Notice of Project Change

THE HUB ON CAUSEWAY

OFFICE TOWER

February 2018

- PREVIOUS PROPOSAL
- REVISED PROPOSAL

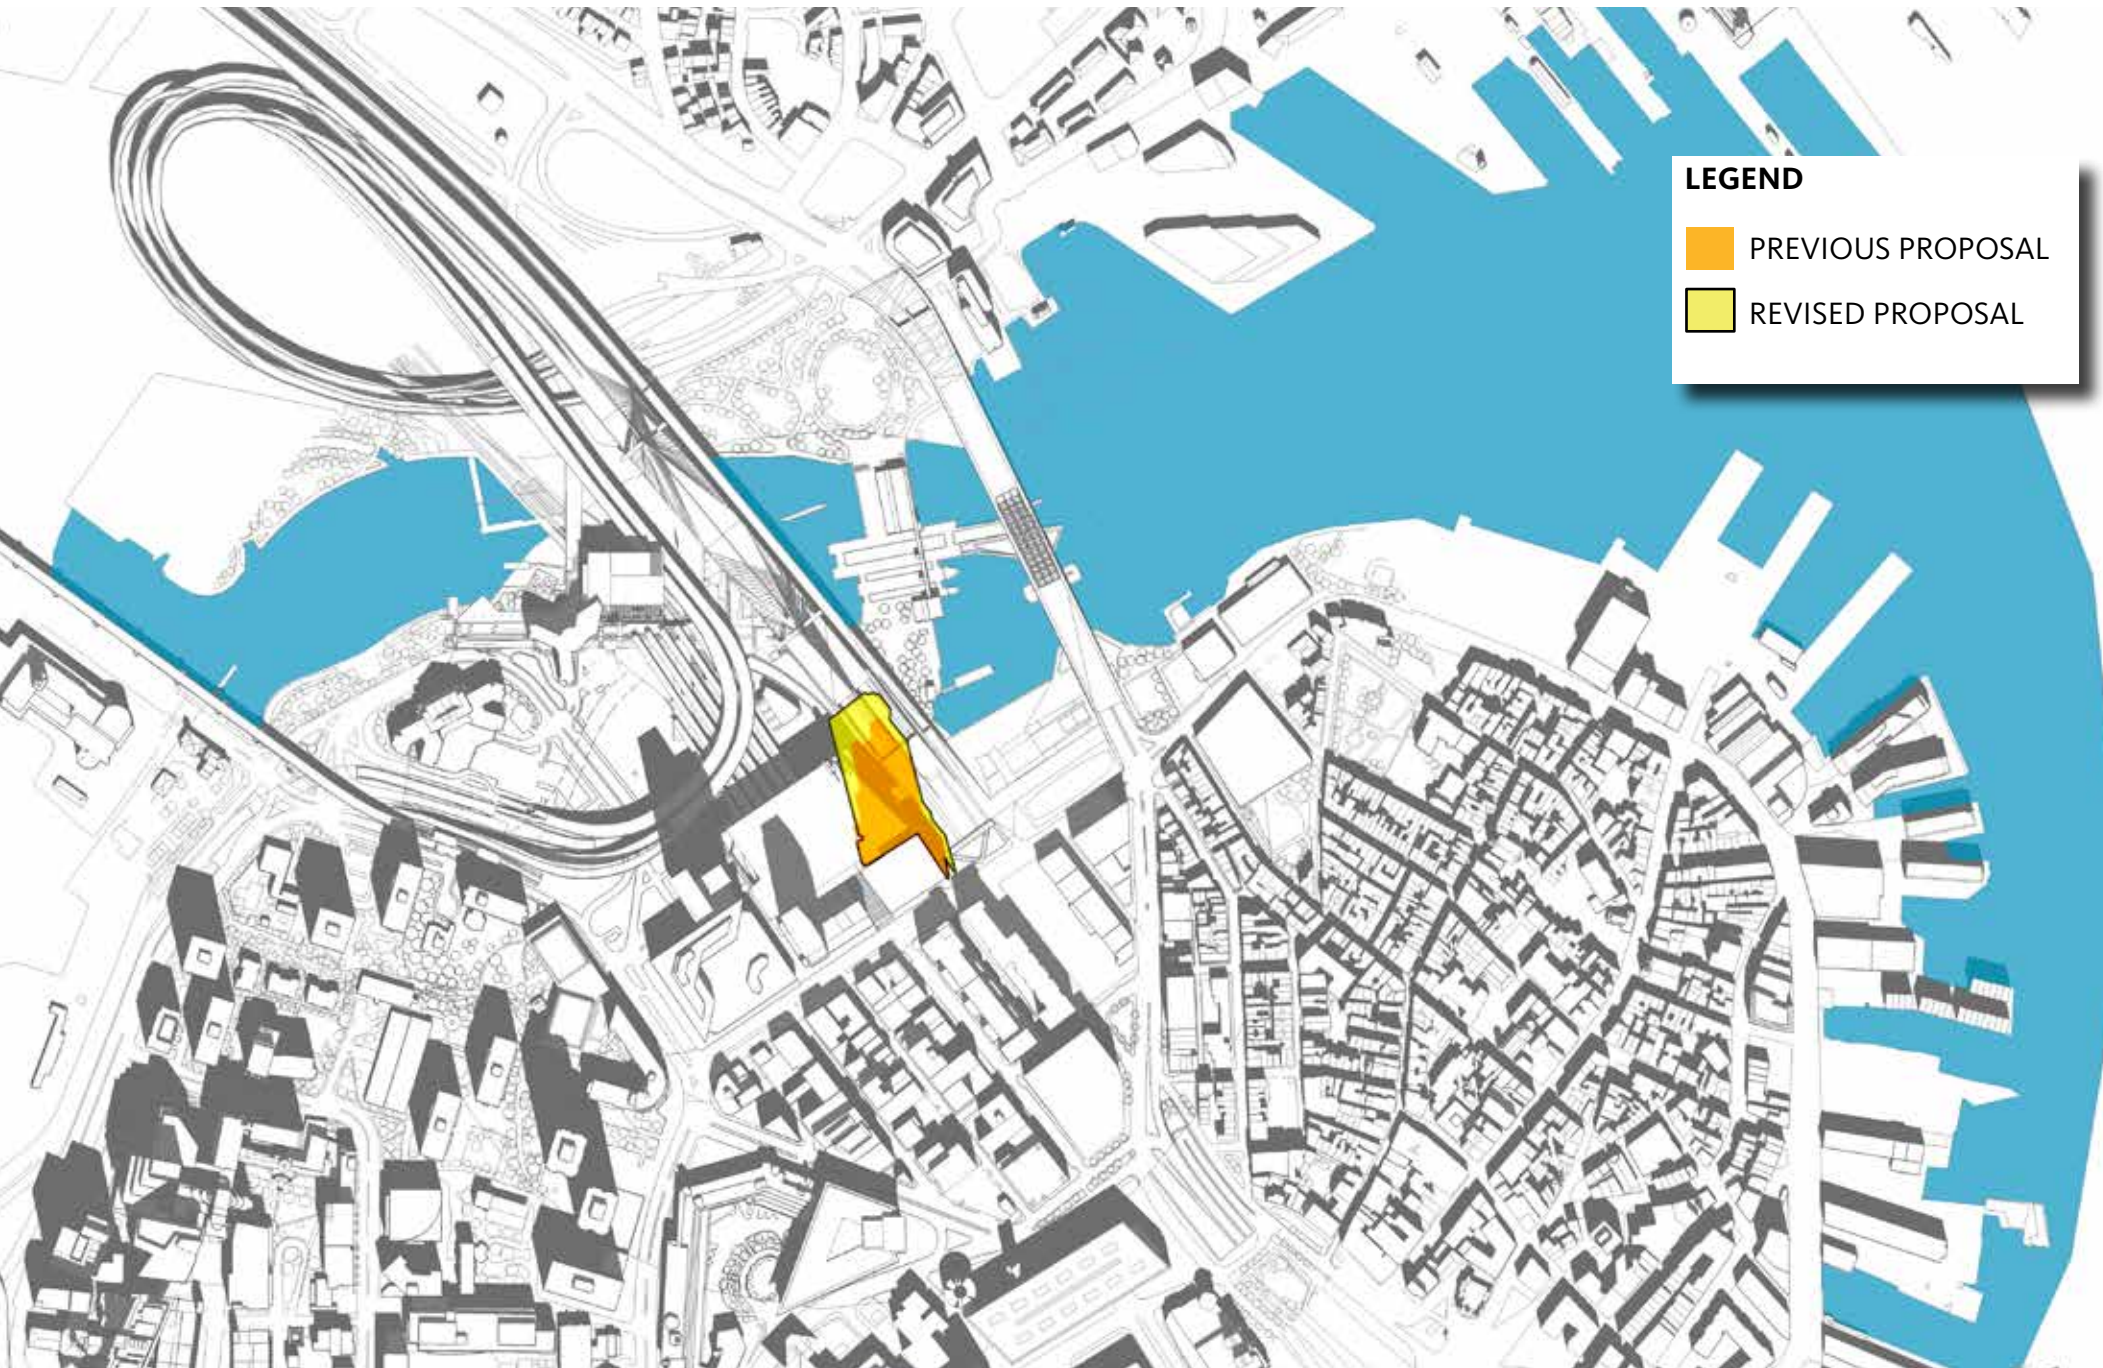
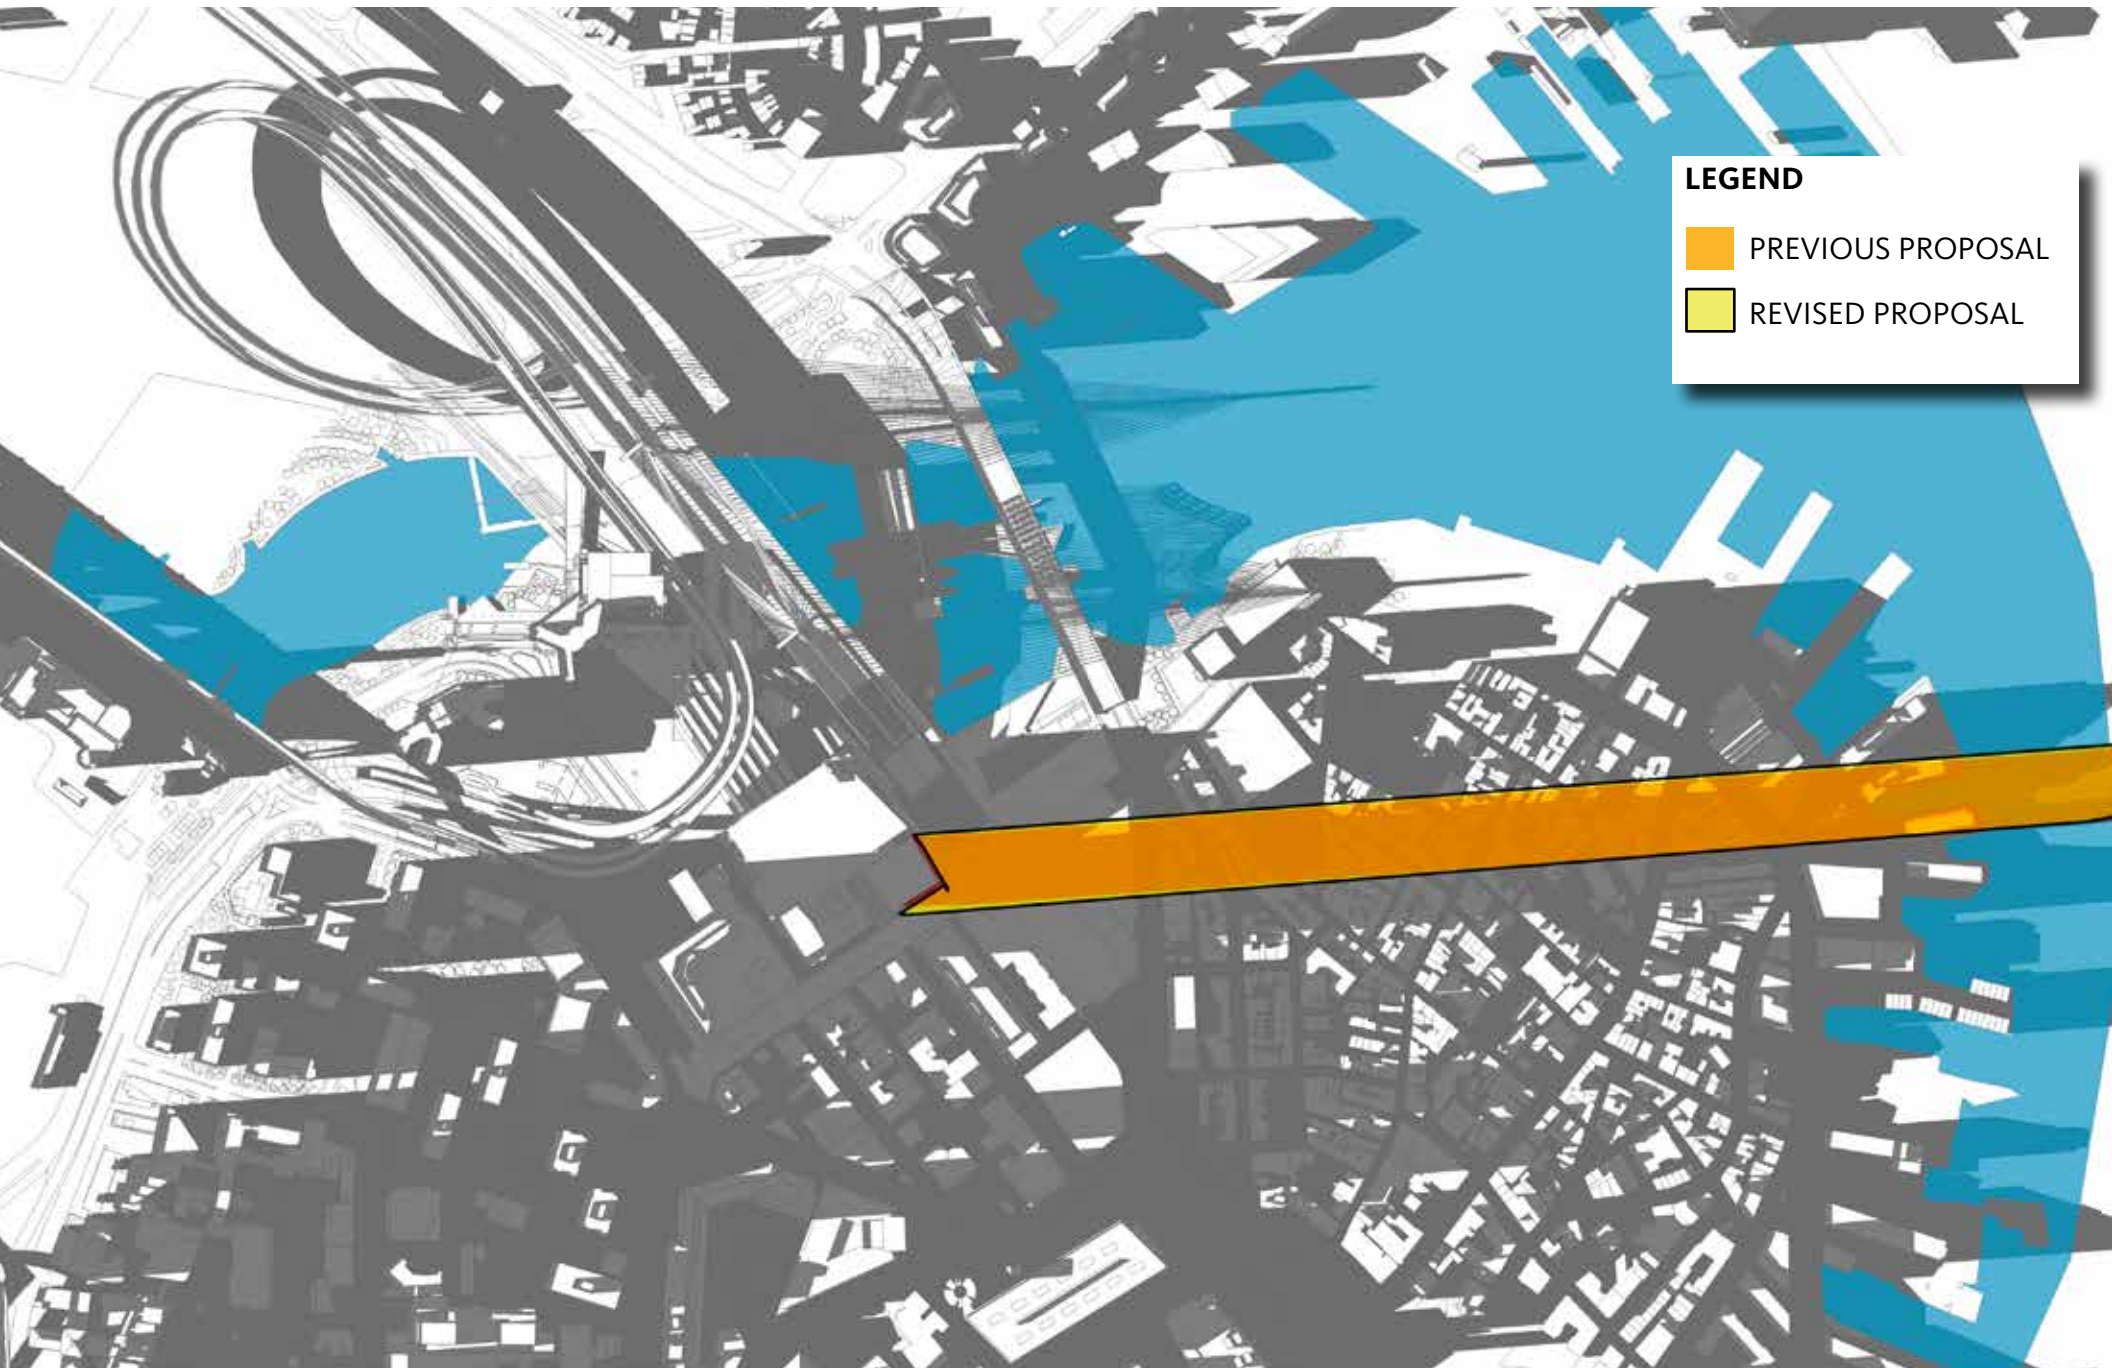
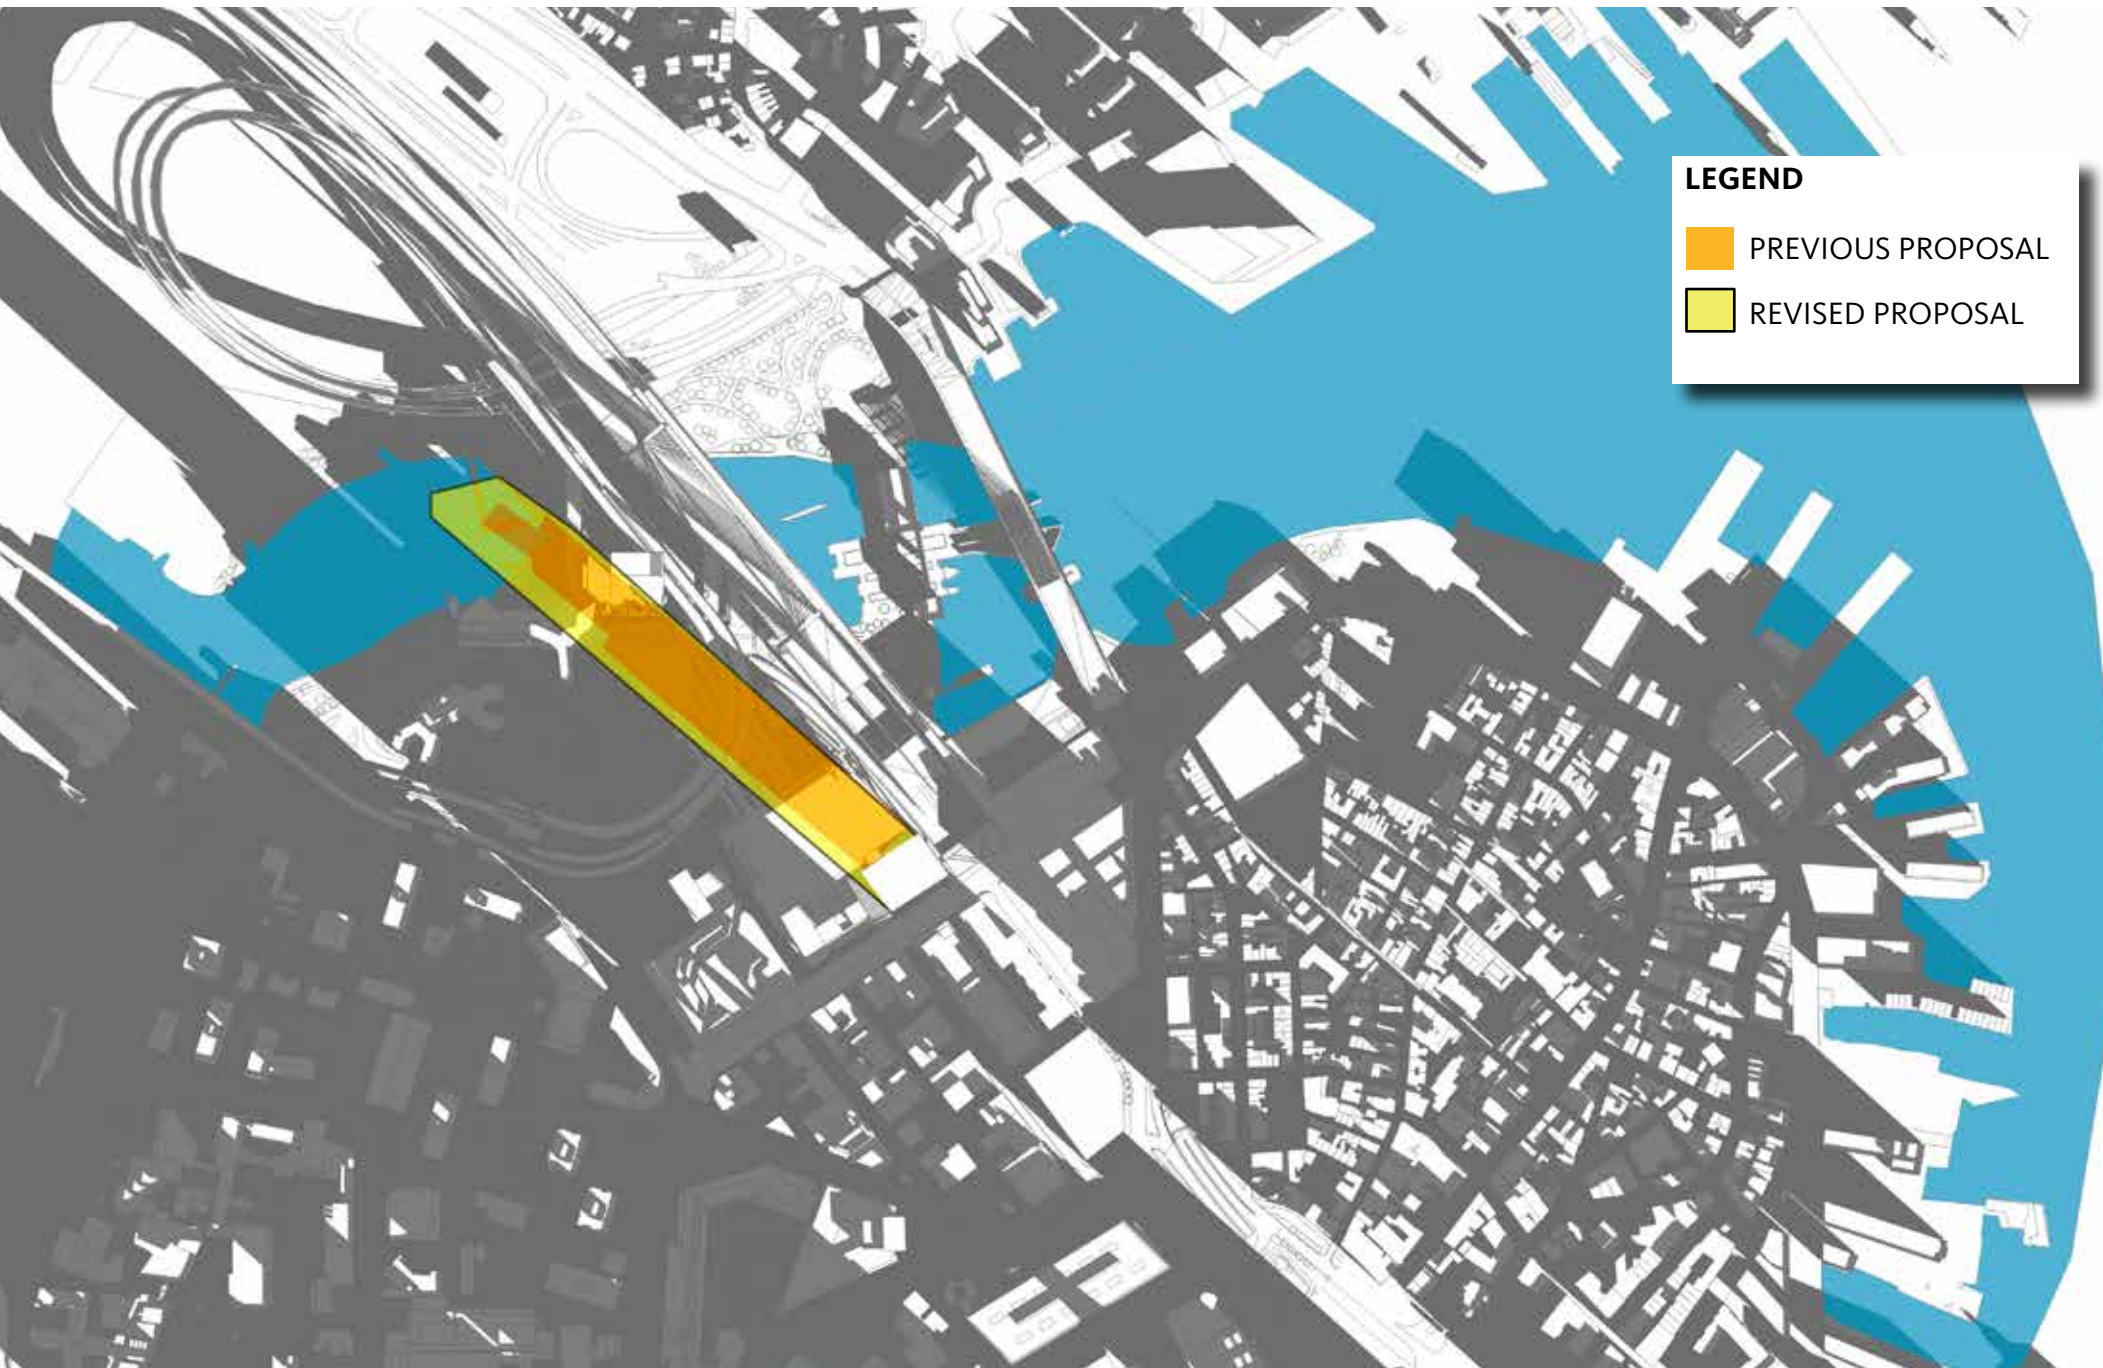
The new proposed Office Tower height of up to 495 feet is measured to the top of the highest occupiable floor. With the inclusion of an occupiable roof deck in the improved Office Tower design, the top floor (which previously was limited to mechanical equipment and was therefore excludable from the height calculation) is now included in height. This design change added approximately 30 feet to the height calculation for the Office Tower, without actually increasing

the physical height of the building. Overall, with the higher floor to ceiling expanses and the addition of one floor, the physical height of the Office Tower would be increased by about 45 feet (note: height calculated pursuant to the Boston Zoning Code would increase by approximately 75 feet). The increase in actual height, along with the expanded maximum floor plates, would result in a small extension of shadow, particularly during early morning, early evening and wintertime, when sun angles are low. Much of the additional shadow falls on areas such as the train tracks or areas already in shadow from other buildings. The updated Shadows Studies from the previous PNF Supplemental Information submittal dated December 6, 2013 (See Figures 4.B.1 through 4.B.13) show the previous Office Tower shadows in orange, with the proposed building shadow outlined and infilled with yellow. Changes in shadow are due in part to the different height, massing, positioning and orientation of the Office Tower on the Podium, and as mentioned above, are most differentiated when sun angles are low.
